NUCLEAR REGULATORY COMMISSION

ADVISORY COMMITTEE ON REACTOR SAFEGUARDS

FLUID DYNAMIC SUBCOMMITTEE MEETING

DATE: July 29, 1982

APPROXIMATE REPRESENTATION
OF RELATIVE ENCROACHMENT
AREA

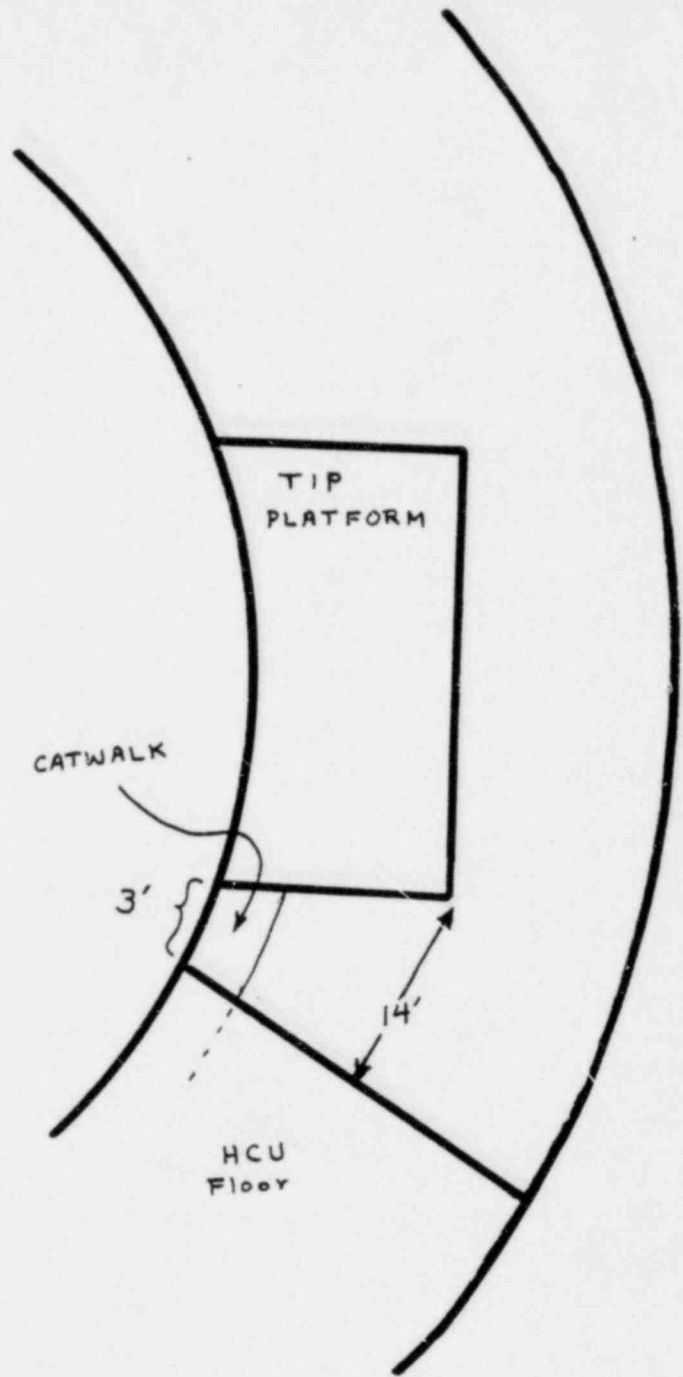
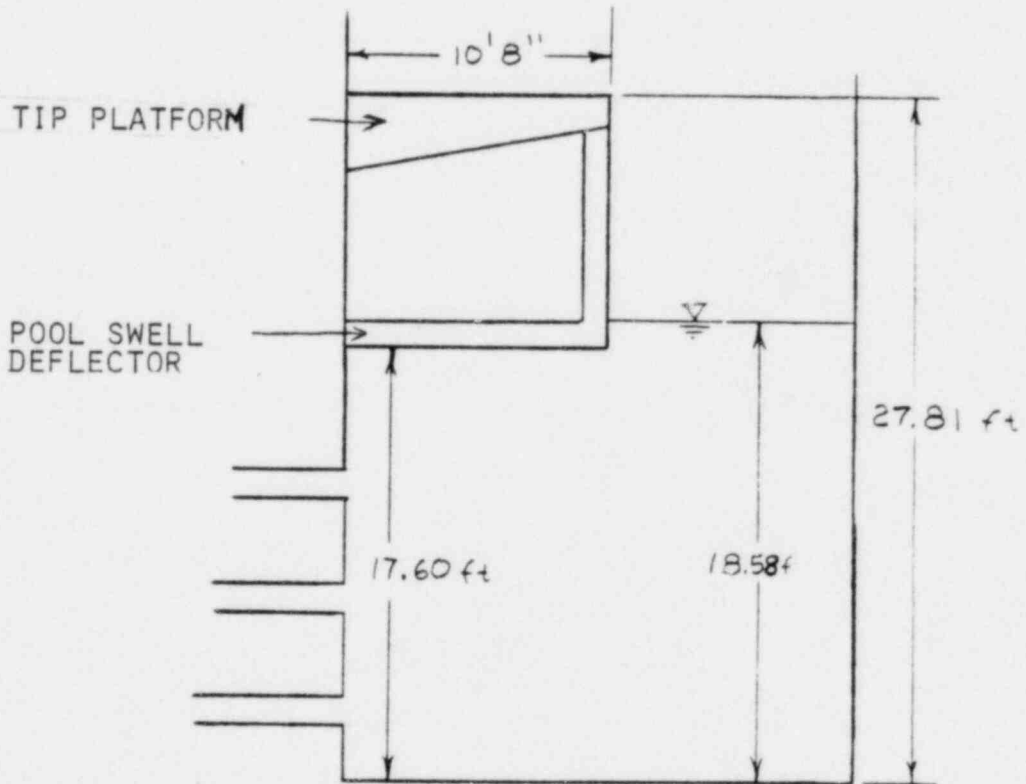
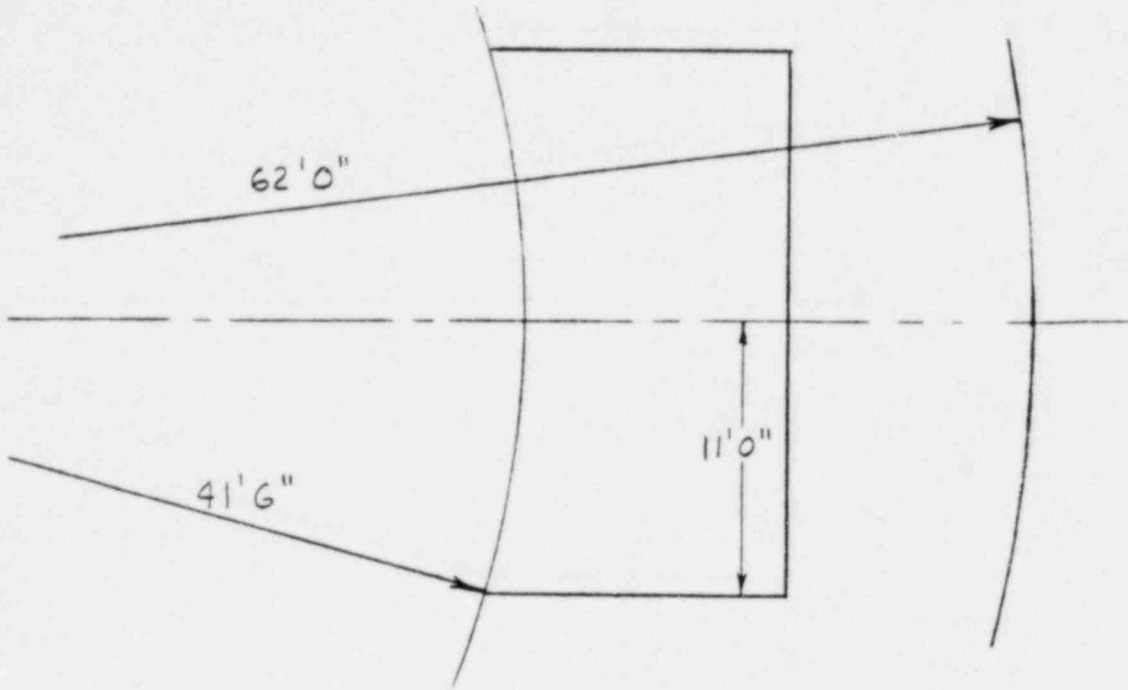
5 The second area dealt with the non-uniform venting
6 at the HCU floor. Mr. Humphrey's concern's that there are
7 possible lateral loads on the HCU floor gradings and a
8 possible increase in local wetwell pressure. This is a
9 concern that applies only to the Mark III's and our previous
10 review approach was that we made a judgment that a little
11 lateral movement of froth would occur. However, we did not
12 perform detailed analysis. Since then we have done some
13 analysis on this issue and our consultants at B & L looked
14 at the problem in some detail and they have concluded that
15 90 percent, or even close to 100 percent of the froth droplets
16 would be stopped at the HCU floor and would not move laterally.

4. EVALUATE BOUNDING LOADS ON HCU SUPPORT STEEL PROVIDED BY LATERAL MOVEMENT OF POOL SWELL FROTH.

GGNS
Relationship of Encroachment
to HCU Floor

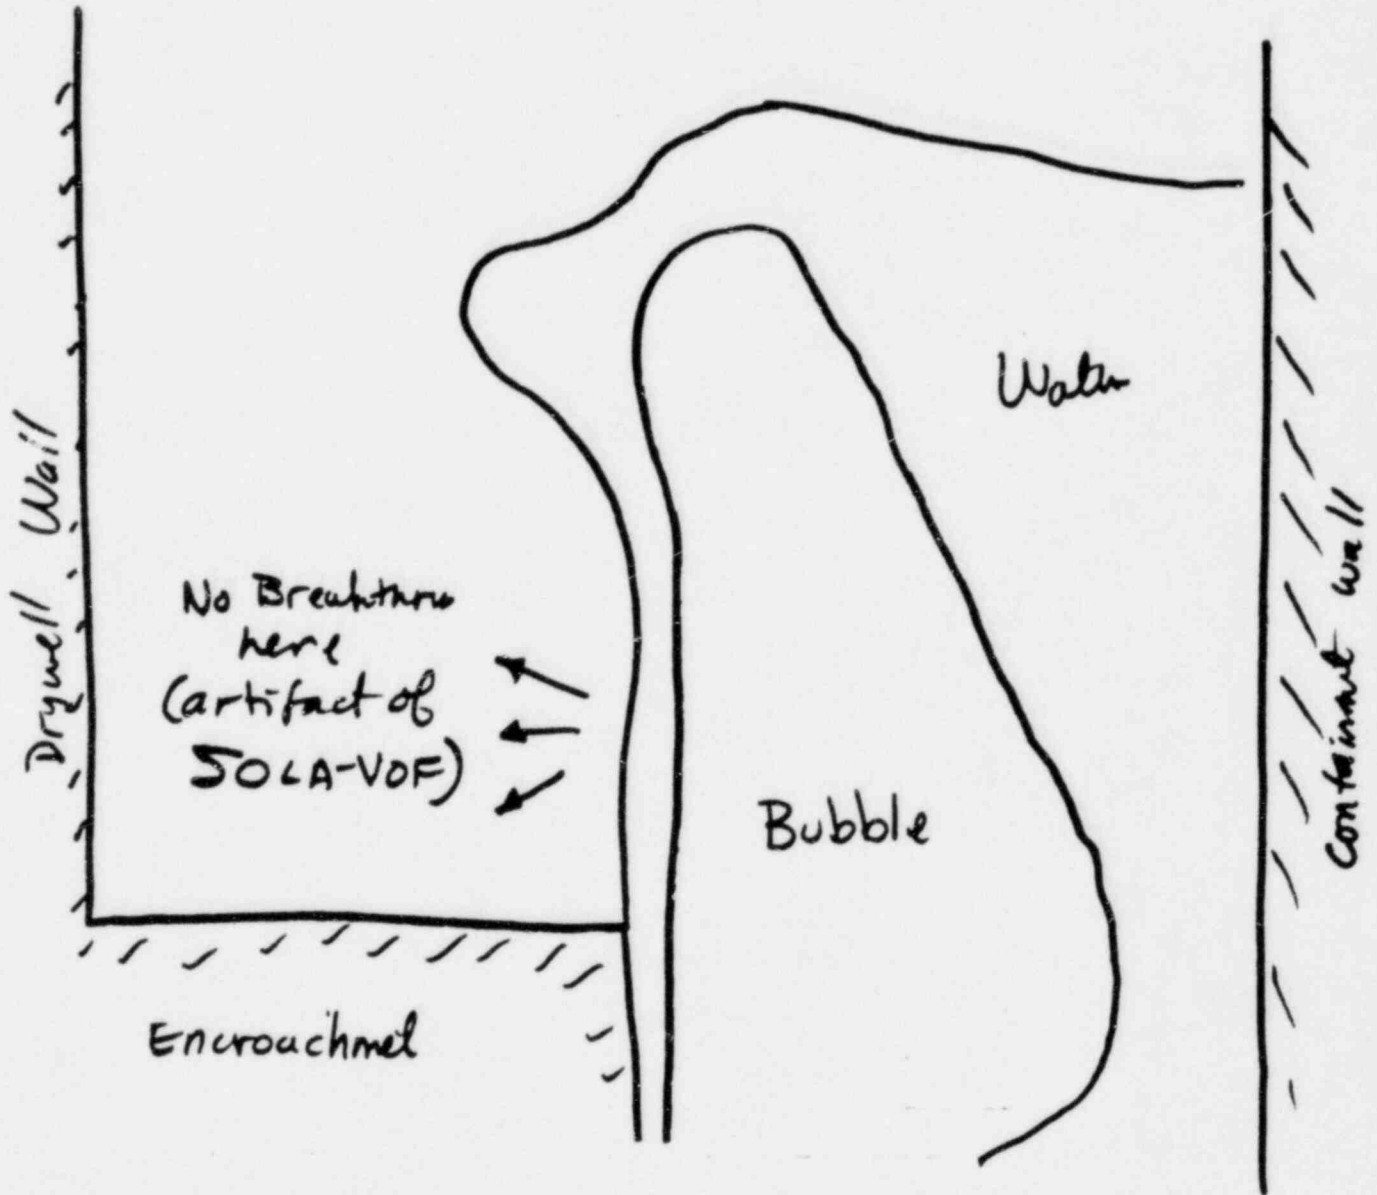
4 However, we haven't been able to completely resolve
5 this issue and we are looking for some more justification,
6 some more analysis to show that the percent increases and
7 velocity breakthrough height, whatever, are bounded by the
8 current numbers used by an MP&L designed plant.
